To: Brittany Hogaluk
Public Registry Coordinator
Nunavut Impact Review Board

From: Luis Manzo, Director of Lands, Kivalliq Inuit Association

Re: Review of Agnico Eagle Mines Limited's Meliadine Gold Mine Project 2022 Annual Report;
NIRB File No.: 11MN034

Figure 1. Wildlife survey and incidental sightings based on 2023 Annual Report (App. 25, S.9.0 Table 8).

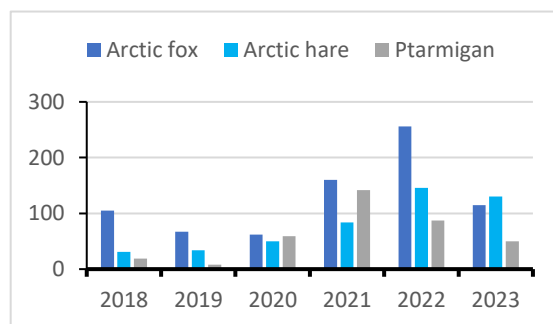
Although the numbers do not include any measure of survey effort, they likely capture broad trends. There was no cross-reference to the similar trends for foxes and hares detected on the remote cameras (App.25, App. G, Table 6.2.1).

The trends include wildlife likely to fluctuate or cycle in number (Arctic Fox, Arctic Hare and Ptarmigan). Agnico Eagle relies on tables but in some cases, graphs may draw the reader's attention to the trends (Figure 1). The trends are likely predictive for monitoring and mitigation. For example, if the sightings of Arctic foxes peaked in 2022, then it is uncertain whether the increased mitigation in 2023 (App. 25, S. 9.5.2) was effective or that there were fewer foxes. The increasing trend in raven sightings (App. 25, S. 9.0, Table 8) may reflect an increase in scavenging opportunities, whether the trends include those species which are presently declining (App. 25, S.85).
